DWR EXHIBIT I
Application, File No. 45,574

APPLICATION FOR PERMIT TO
APPROPRIATE WATER FOR BENEFICIAL USE
Filing Fee Must Accompany the Application
(Please refer to Fee Schedule attached to this application form.)

ASR Project DW-7

CITY OF WICHITA
 PRELIMINARY DESIGN
 DIVERSION WELL
 DW-07

Figure 1. - Equus Beds Groundwater Management District No. 2
 Aquifer Storage and Recovery Project Map
 July 13, 2004

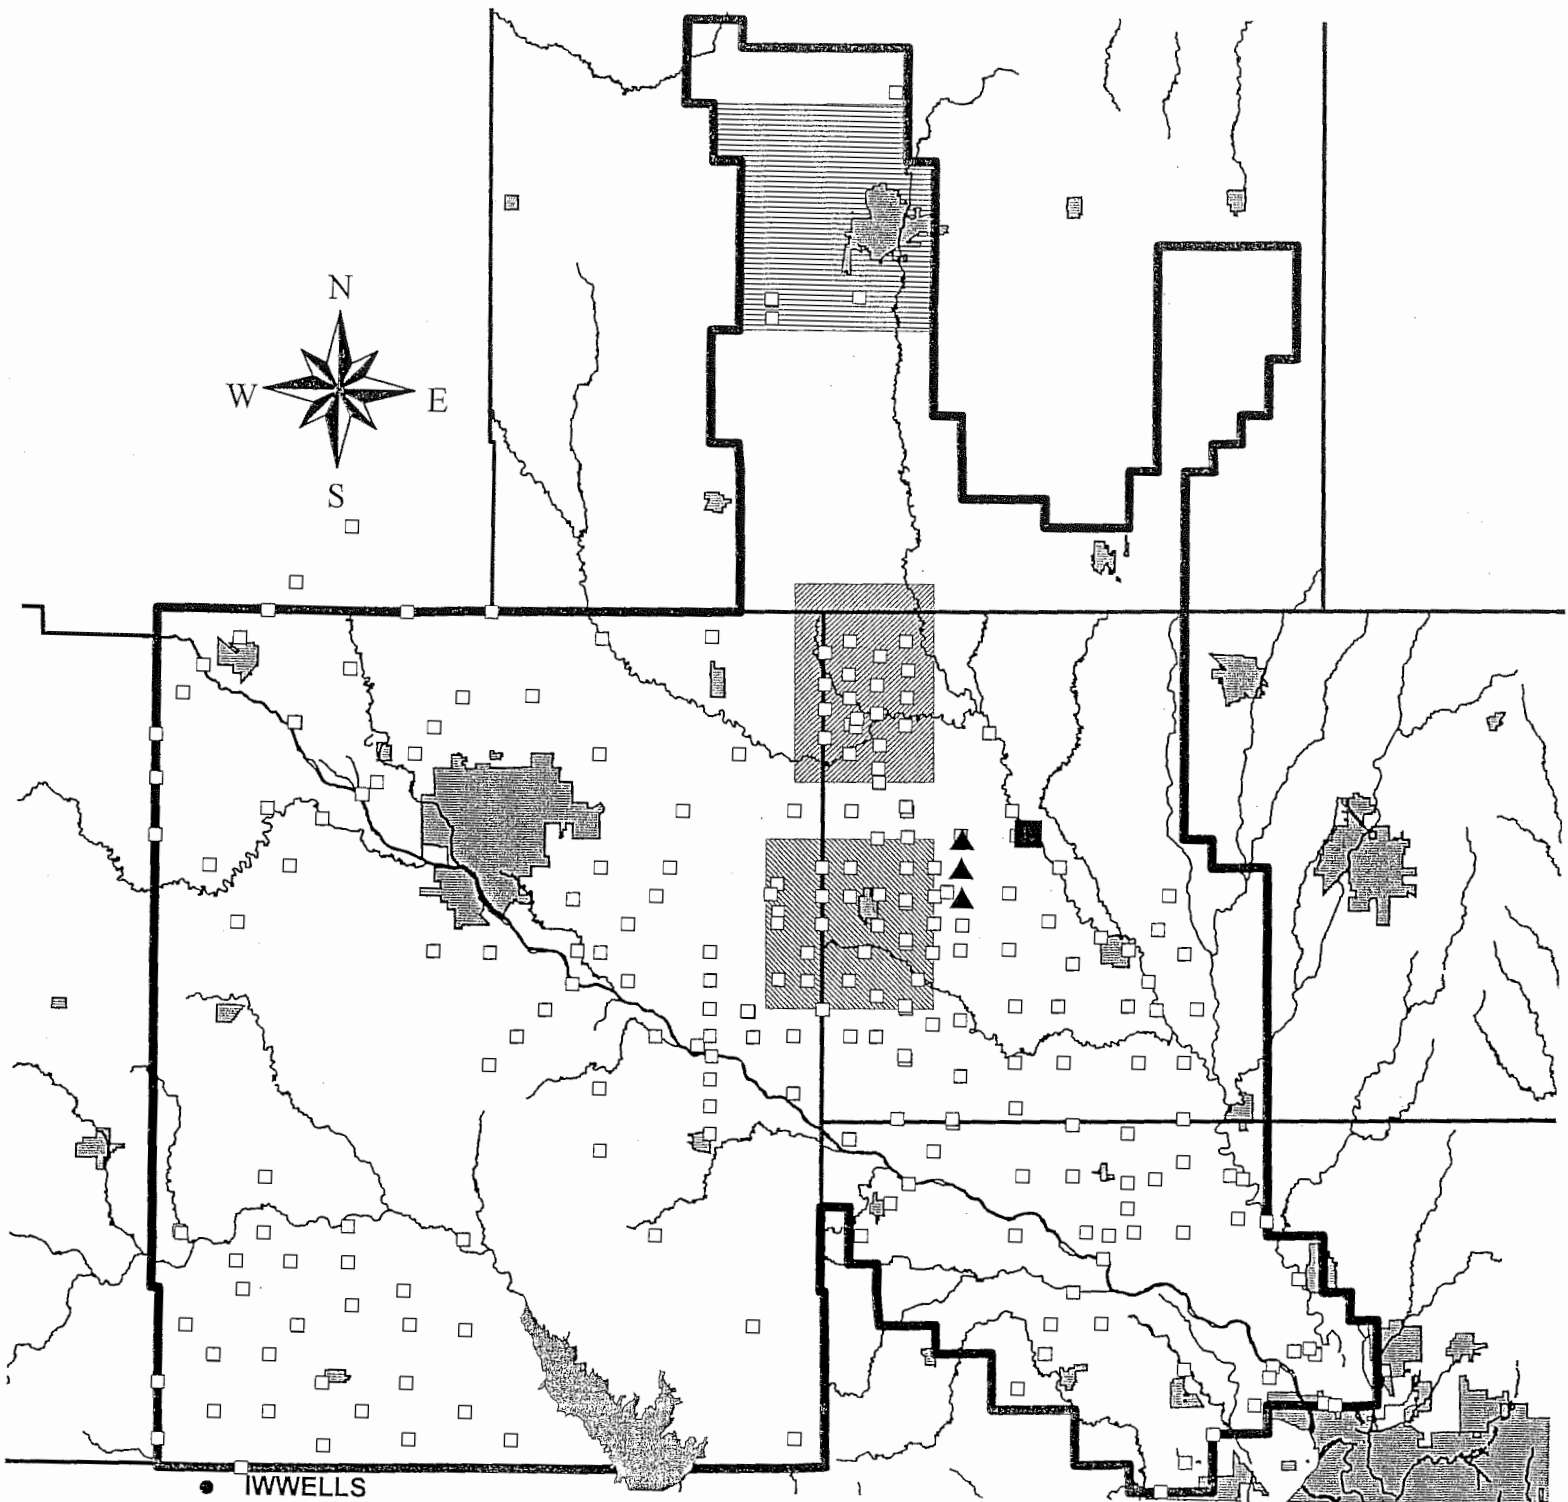
The proposed bank storage well shall be utilized only when river flow exceeds 42 cubic feet per second (cfs) from April through September, and 20 cfs from October through March, as measured at the United States Geological Survey (USGS) gage located at Highway 50 near Halstead (figure 1).

Figure 2. – Application No. 45574 Site Map - NW 08-23S-2W
 Prepared by: Equus Beds Groundwater Management District No. 2 - 06/30/04

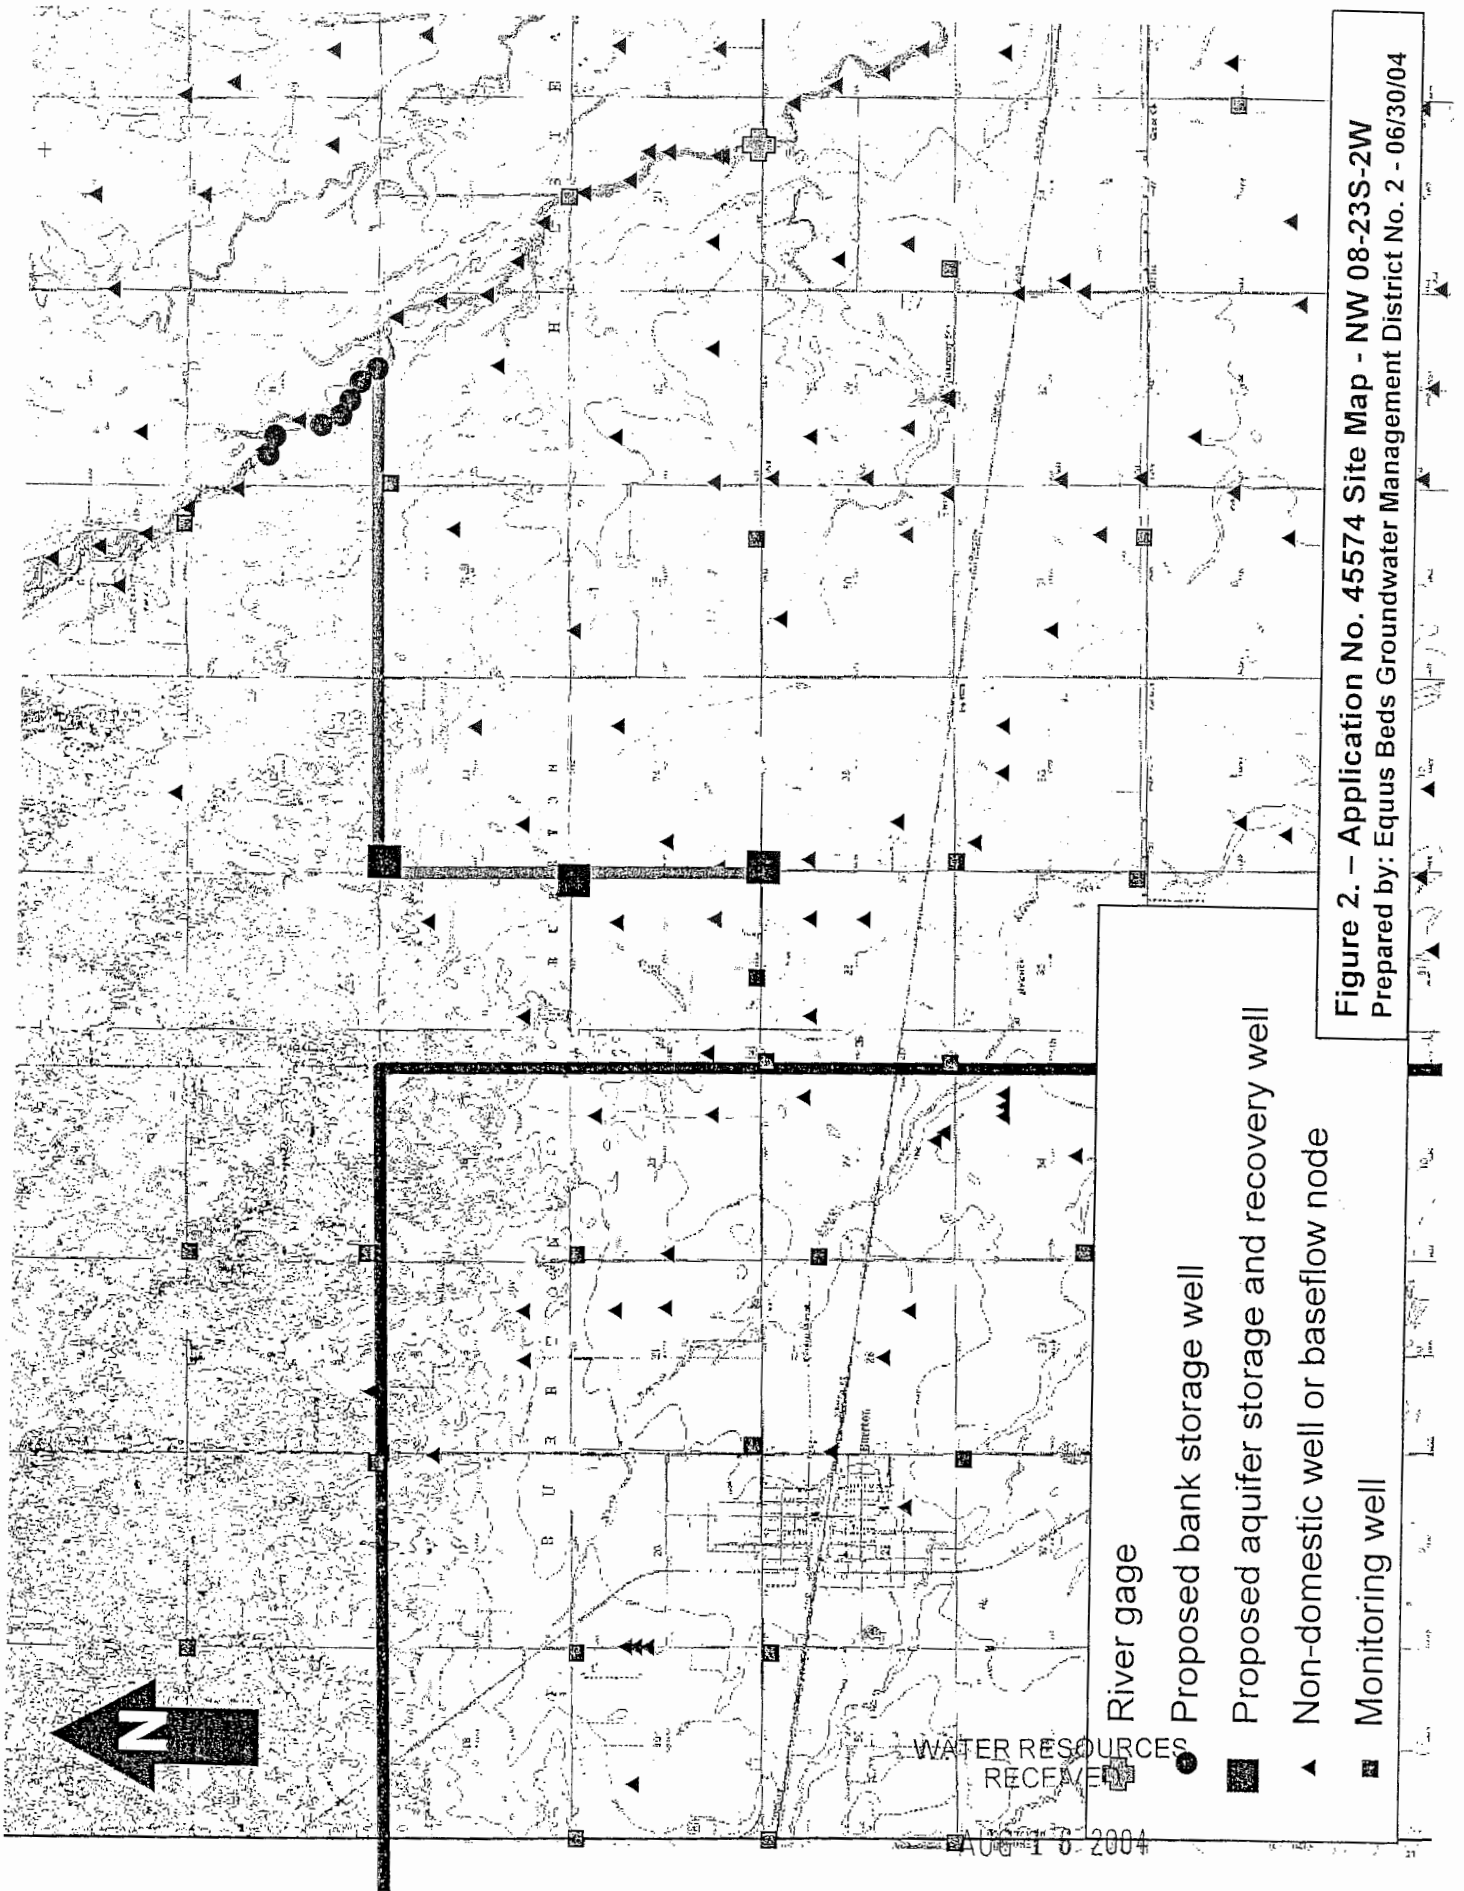
The proposed source water for the applicant's artificial recharge use in the aquifer storage and recovery system, is bank storage water to be diverted from a proposed well located in the SE-SW-NW of Section 8, Township 23 South, Range 2 West (figure 2).

Figure 4. –
 Application
 No. 45574
 Lithologic Log
 and Construction
 Design for
 Bank Storage
 Well

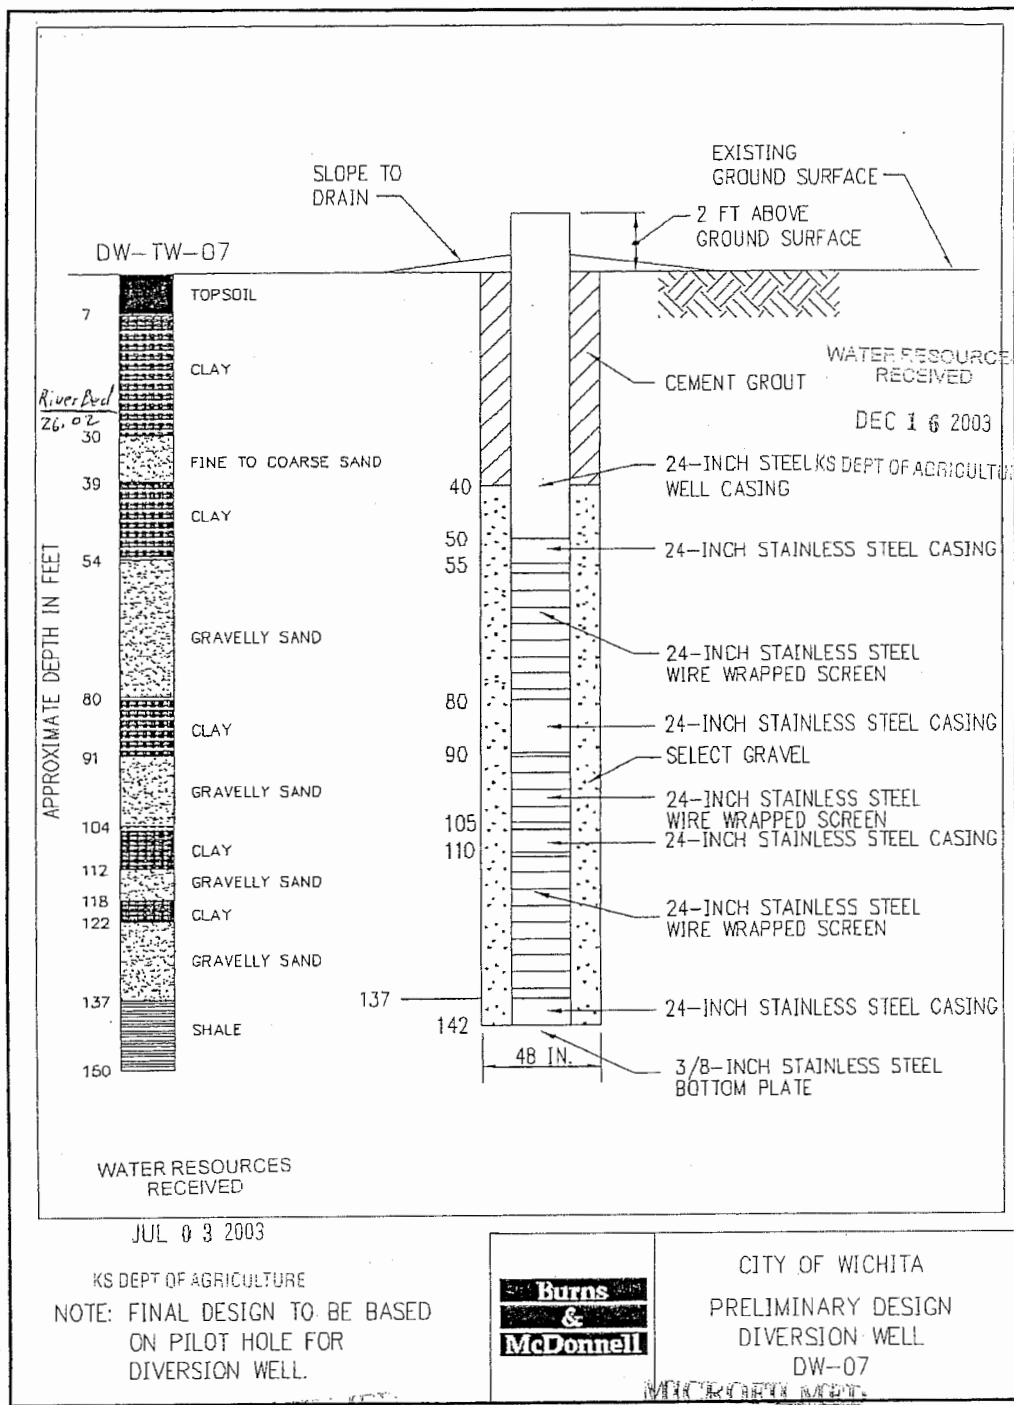
The lithologic log of the proposed well site indicates that the aquifer is comprised of alternating sand and clay layers, with shale encountered at 137 feet (figure 4). The log indicated that clay units exist at depth ranges of 39 to 54 feet bls, and 80 to 91 feet. The horizontal extent and continuity of the clay units were not determined. The lower portion of the aquifer consisted of interbedded sand and clay units throughout from 91 to 137 feet bls.

The application's proposed well depth is 137 feet bls (figure 4), with proposed screen intervals set from 55 to 80 feet bls, and 90 to 137 feet bls. The well is proposed to be screened in the lower portion of the aquifer below the clay unit located from 30 to 54 feet bls. The applicant proposes to utilize a 24-inch diameter well casing and screen.

Figure 5.

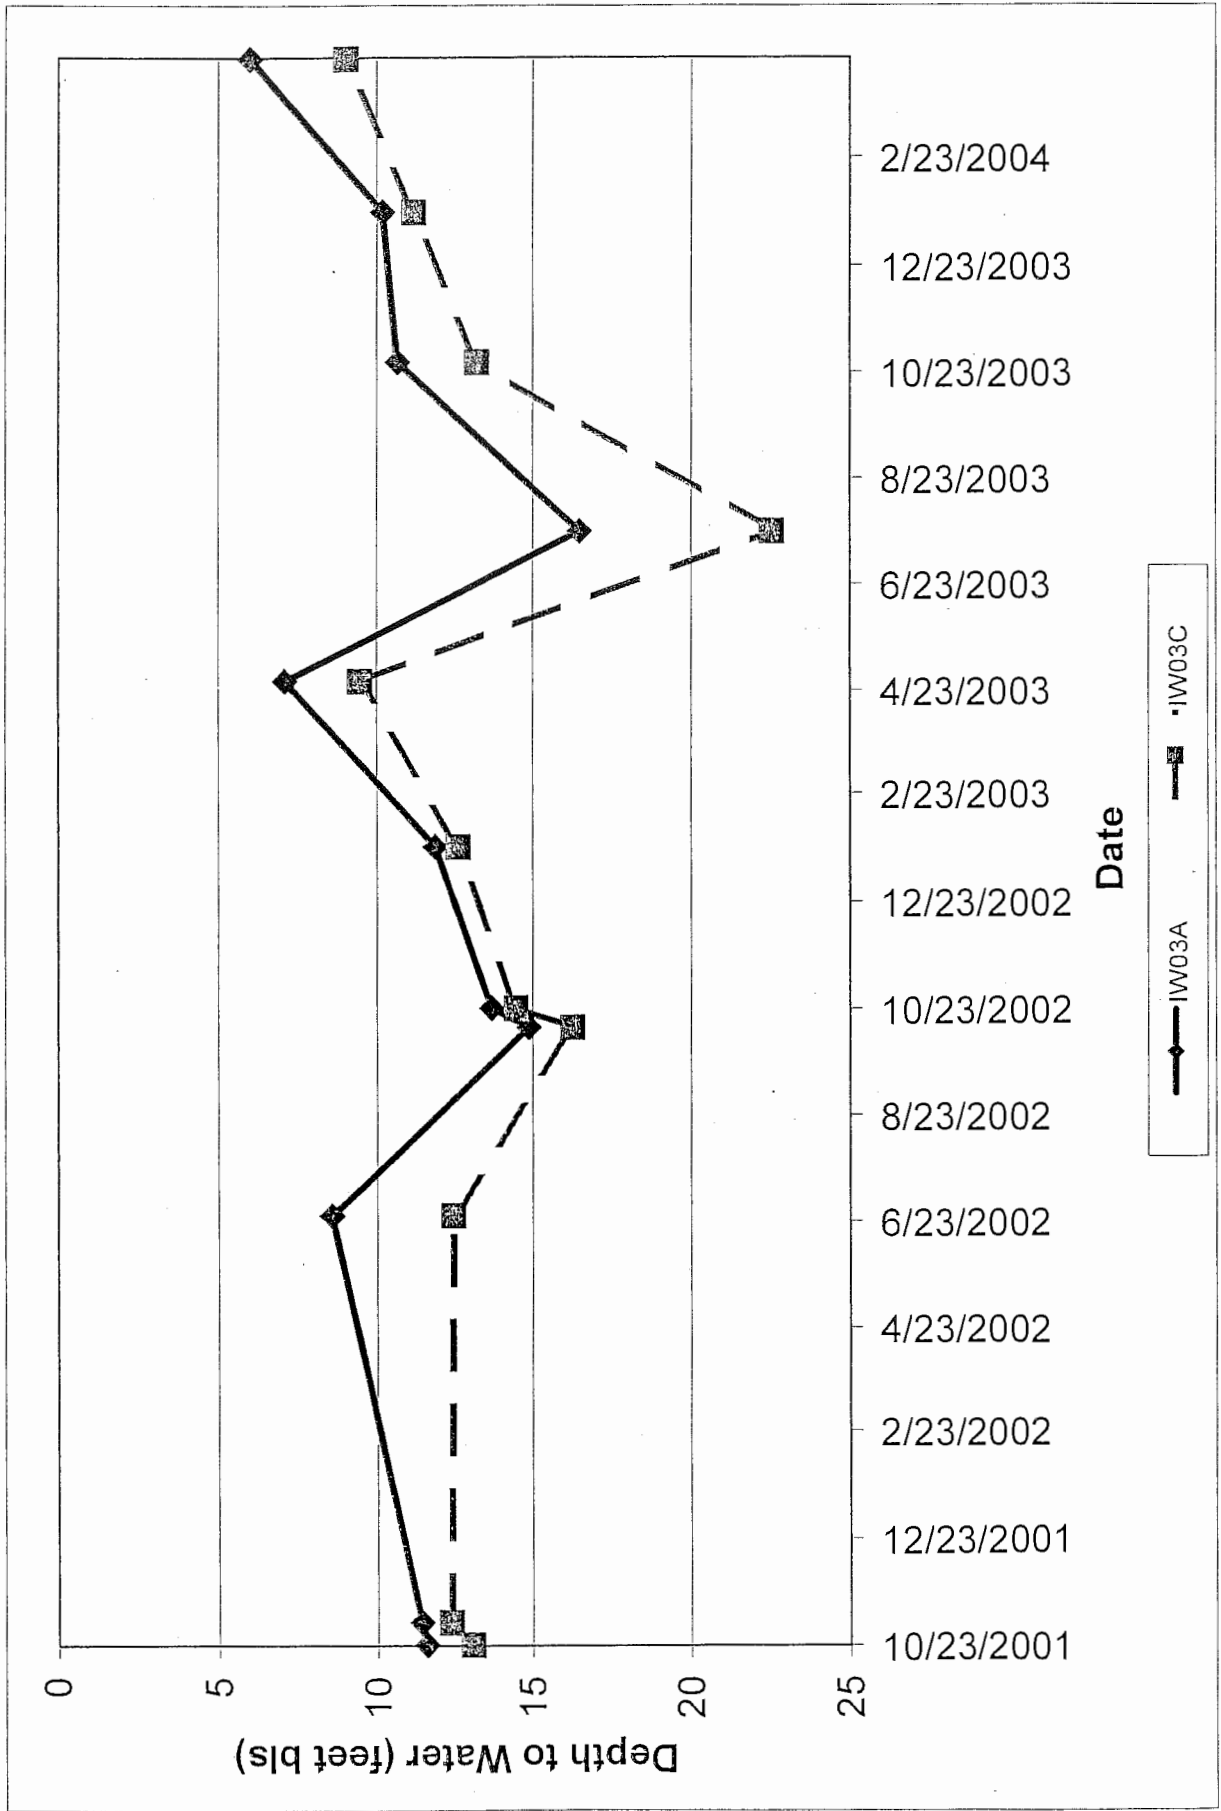
Water level data has been recorded by the District at groundwater monitoring site IW03 located approximately 0.6 mile south-southwest of the proposed well site (figure 3). Water levels recorded at the site during the period of record from October 2001 to April 2004 (figure 5), ranged from 5.99 to 16.49 feet bls in IW03A (total depth 34 feet), and from 9.03 to 22.53 feet bls in IW03C (total depth 138 feet). The IW03C lithologic log reported that depth to bedrock was 166 feet bls.

IW03 water level data (figure 5) indicated that a head difference ranging from approximately 1 to 6 feet existed between the upper zone (A well) and the lower zone (C well). The water levels in both zones exhibited similar responses to water table fluctuations, indicating a hydraulic connection. The fluctuation responses indicated leakage occurrence from the upper zone to the lower zone. Pumping effects exhibited in the lower zone also affected water levels in the upper zone. The correlation between the data sets indicated that the clay unit separating the two zones is not continuous throughout the area.
